Cross River Rail project

Coordinator-General's change report no. 14

July 2024

Figure 4.1 Construction Stage 1 – Site Establishment

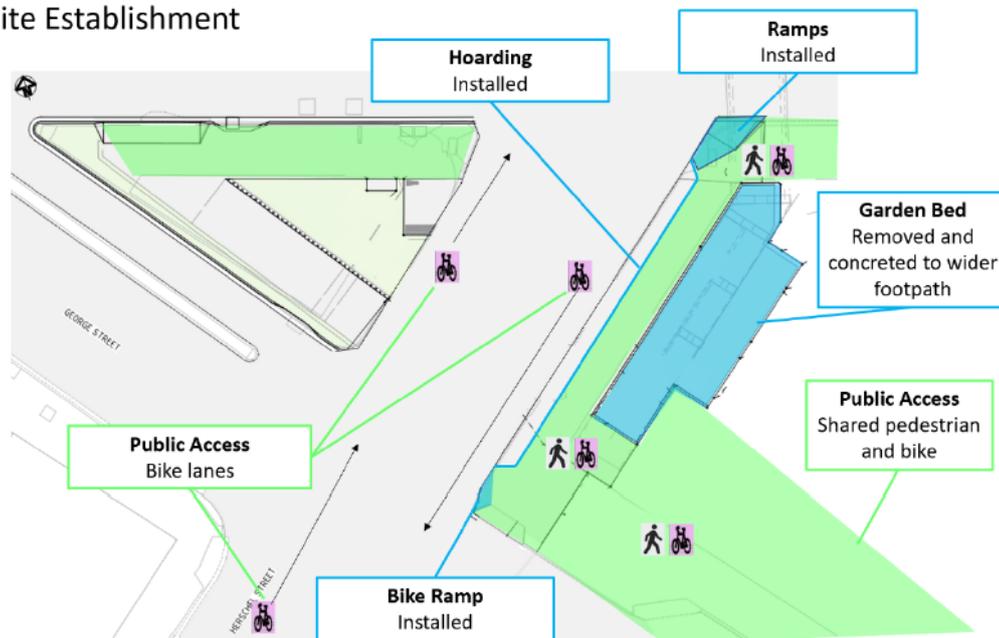
Once the road has been closed to vehicles, the construction site will be established in two stages. Stage 1 (Figure 4.1 below) involves the installation of hoarding (solid and temp fencing), construction of ramps, and removal of an existing garden bed to create a wider footpath to maintain pedestrian and cycle access through the site during the construction phase. Once the new wider path is established, Stage 2 (Figure 4.2) will commence with the road and existing pedestrian island being hoarded off.
